UNITED STATES  
NUCLEAR REGULATORY COMMISSION  
WASHINGTON, D. C. 20555-0001

CALVERT CLIFFS NUCLEAR POWER PLANT, UNIT NO. 2

AMENDMENT TO FACILITY OPERATING LICENSE

Amendment No. 162  
License No. DPR-69

FIGURE 3.4.9-1

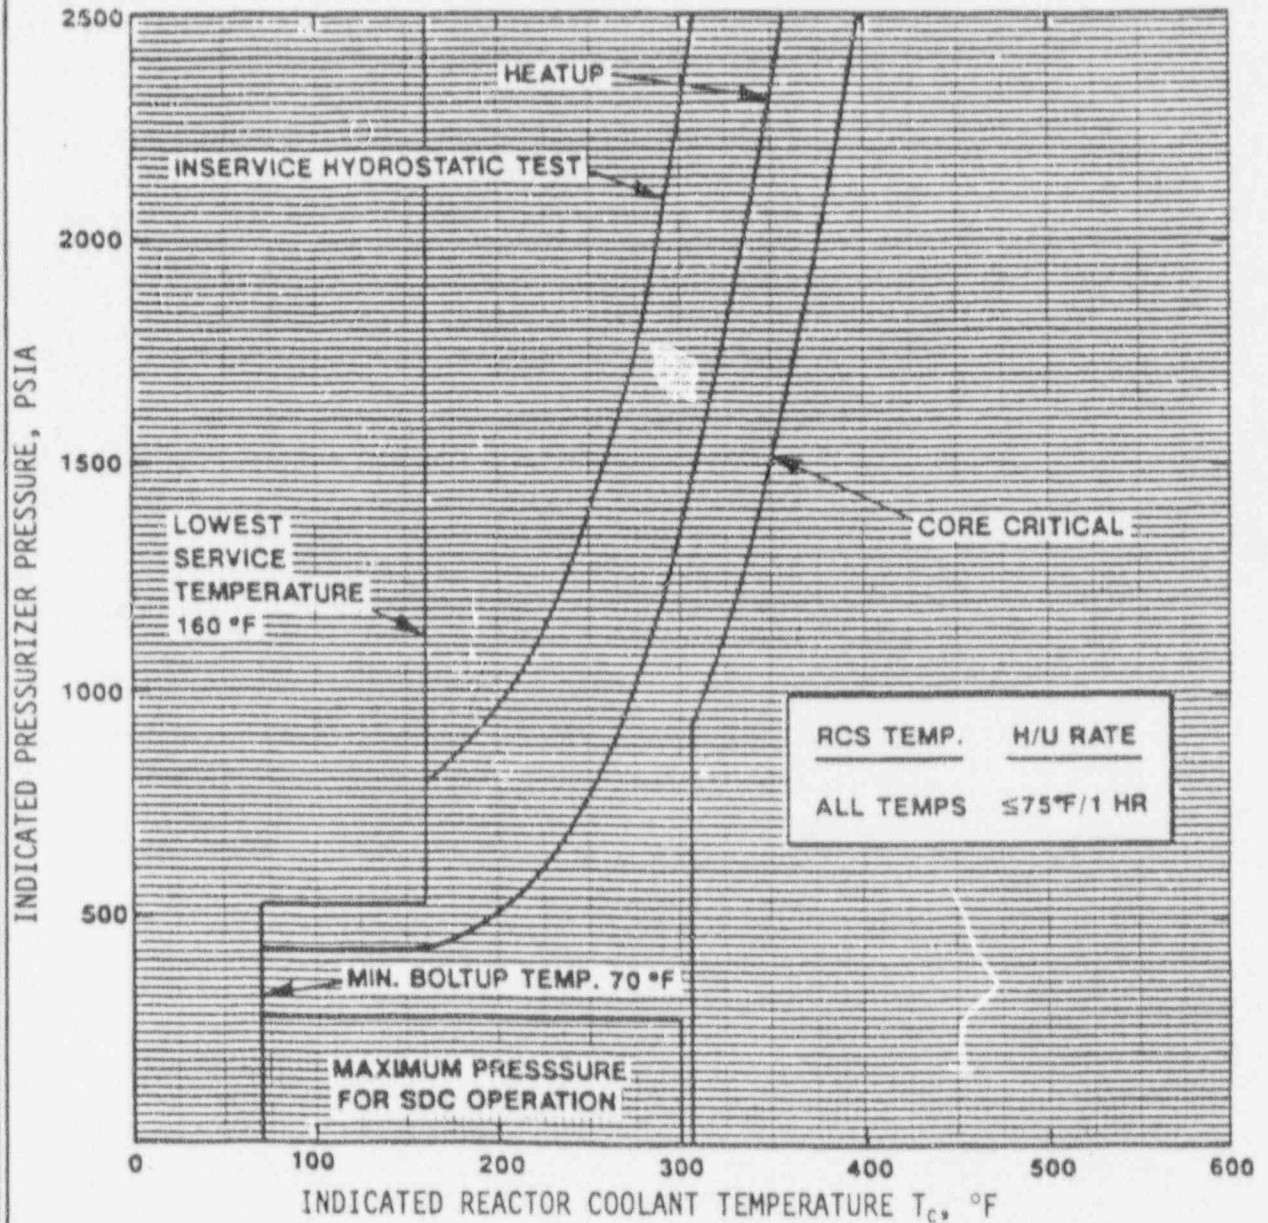
CALVERT CLIFFS UNIT 2 HEATUP CURVE. for FLUENCE  $< 1.92 \times 10^{19}$  n/cm<sup>2</sup>  
REACTOR COOLANT SYSTEM PRESSURE TEMPERATURE LIMITS

Similarly, 10 CFR Part 50 specifies that core critical limits be established based on material considerations. This limit is shown on the heatup curve, Figure 3.4.9-1. Note that this limit does not consider the core reactivity safety analyses that actually control the temperature at which the core can be brought critical.

FIGURE 3.4.9-2

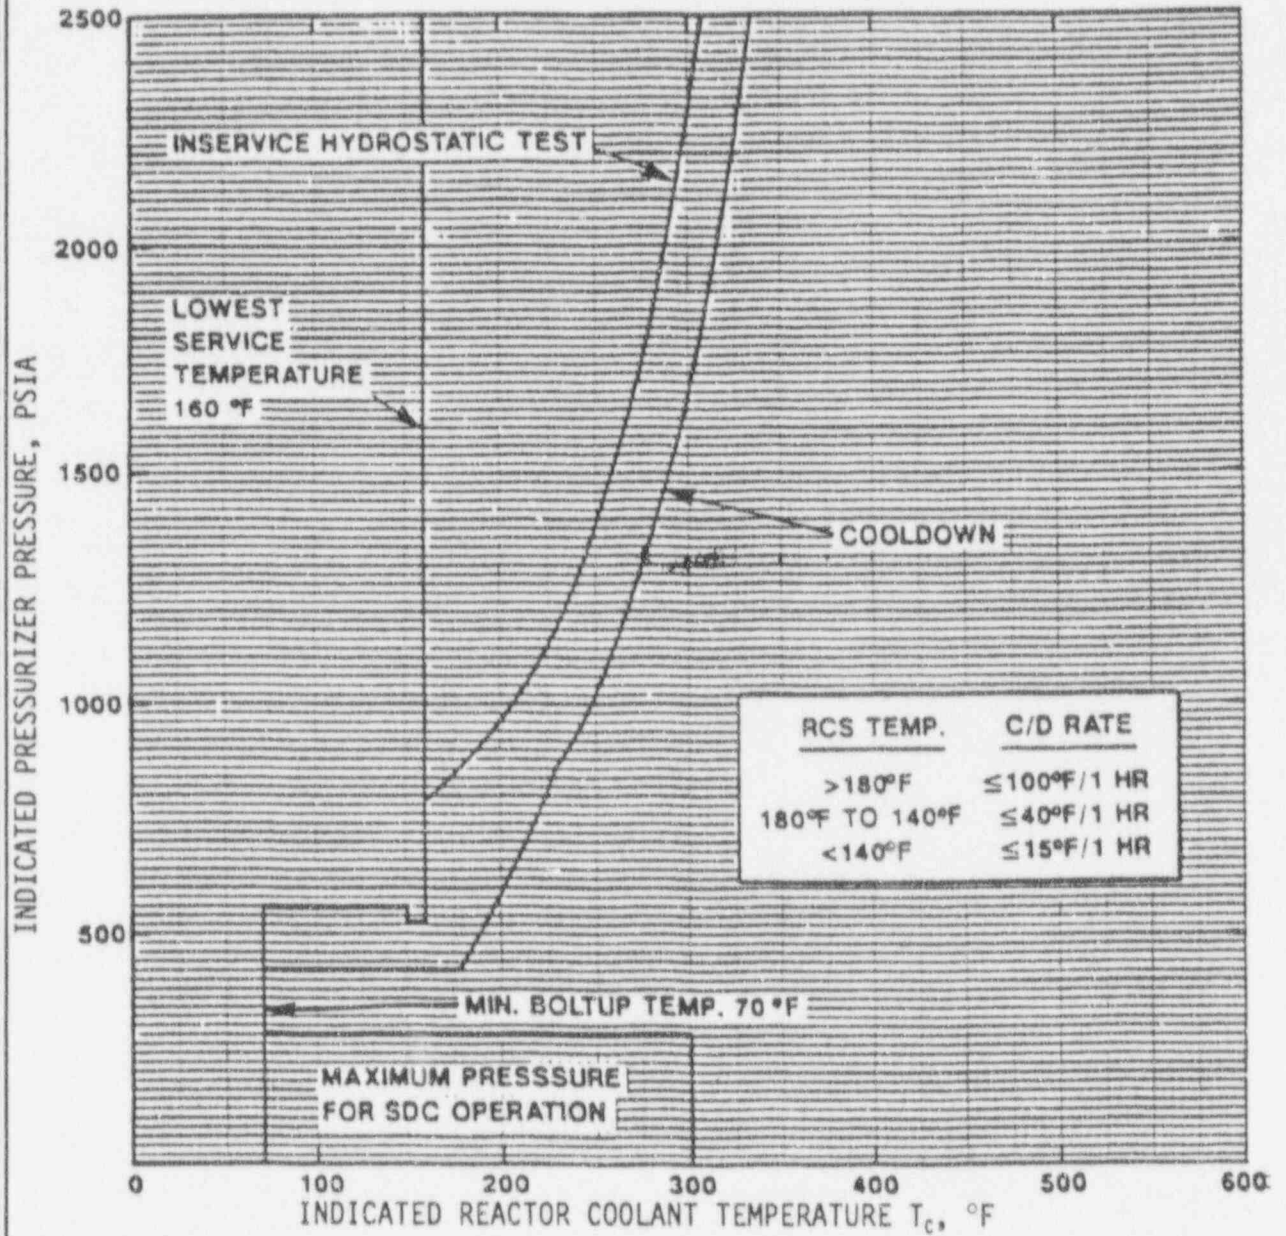
CALVERT CLIFFS UNIT 2 COOLDOWN CURVE, for FLUENCE  $< 1.92 \times 10^{19}$  n/cm<sup>2</sup>  
 REACTOR COOLANT SYSTEM PRESSURE TEMPERATURE LIMITS

The horizontal line between the minimum boltup temperature and the Lowest Service Temperature is defined by the ASME Boiler and Pressure Vessel Code as 20% of the pre-operational hydrostatic test pressure. The change in the line at 150°F on the cooldown curve is due to a cessation of RCP flow induced pressure deviation, since no RCPs are permitted to operate during a cooldown below 150°F.
